# UNITED STATES PATENT AND TRADEMARK OFFICE

APPLICATION NO.	FILING DATE	FIRST NAMED INVENTOR	ATTORNEY DOCKET NO.	CONFIRMATION NO.
10/771,991	02/03/2004	Marc Duarte	1948-4837	6281

# Office Action Summary

## **DETAILED ACTION**

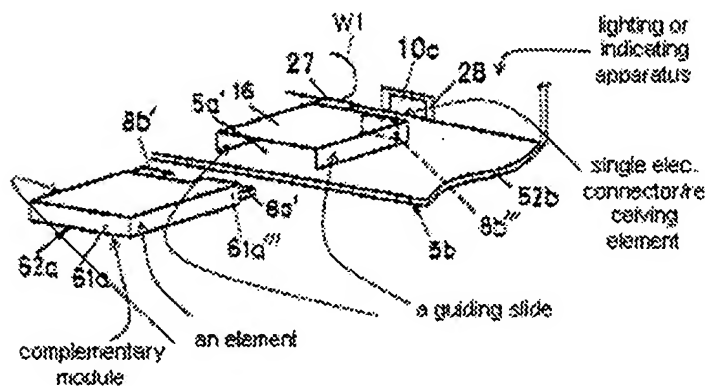
Regarding claim 26, Ueno et al. discloses a reflector (e.g., 3), a light source (e.g., 1), and a casing (e.g., 52a, 52b, 52e, 52f, 52h) which defines a set of faces (e.g., Figures 1, 4, 6-9, 15, 19,

20, 24), having side, lower and upper faces, wherein, the apparatus is adapted to be combined with at least one complementary module (e.g., a lighting device; 62a) with the aid of at least one pair ("left and right portions of the body"; Figure 18; 62c or 10 and 27 in Figure 22) of assembly element comprising a guiding slide (Figures 10-14, 21-23) and an element (shown & indicated in below drawing figure) being adapted to be complementary to at least one end of the slide associated with the element and to slide in the slide, each of the assembly elements of the pair of assembly elements being disposed either on the lighting or indicating apparatus (5a) or on the complementary module ("a lighting device"; 62a), each assembly element in one the pair being disposed in a different one of the components consisting of the lighting or indicating apparatus ("luminaire") and the complementary module (a lighting device; 62a), the module having a single electrical connector (8b'; Figures 10, 13, 14, 16 and 17), and the apparatus (luminaire) having a single receiving element (8b; Figures 10, 13, 14, 16 and 17) for the connector of the complementary module (lighting device; 62a).

Ueno et al. failed to disclose the details of a **projecting** element, where the element being inserted into one end of the slide.

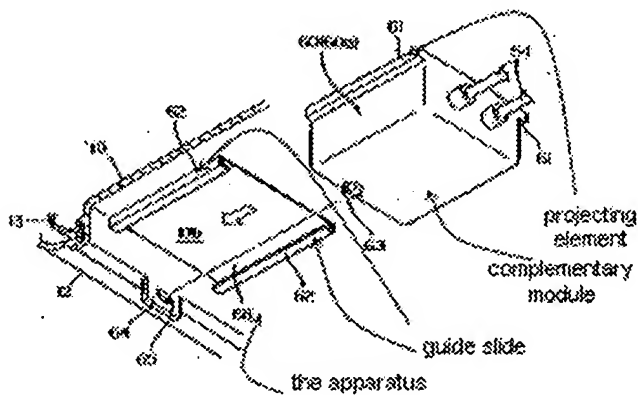
Watanabe et al. teaches specific details of the apparatus (e.g., 10) is adapted to be combined with at least one complementary module (e.g., 60(60a)) with the aid of at least one

pair (e.g., Figure 7) of assembly element comprising a guiding slide (e.g., 62) and a projecting element (e.g., 61) being adapted to be inserted at least into one end of the slide associated with the projecting element and to slide in the slide, each of the assembly elements of the pair of assembly elements being disposed either on the lighting (10) or indicating apparatus (10) or on the complementary module (60(60a)), each assembly element in one the pair (Figure 7) being disposed in a different one of the components consisting of the lighting or indicating apparatus (10) and the complementary module (60(60a)), the module having an electrical connector (e.g., 54).

It would have been obvious to one of ordinary skill in the art at the time of the invention to modify guiding slide(s) & element(s) of Ueno et al. to include projecting element(s) that is being inserted into the guiding slide(s). The following modification would have result in more precise assembly between the lighting/indicating apparatus and the complementary module. In addition, the modification would have provided an easier method of replacing the complementary module (in this case, the complementary module being outside the lighting/indicating apparatus) during replacement or an initial installation.
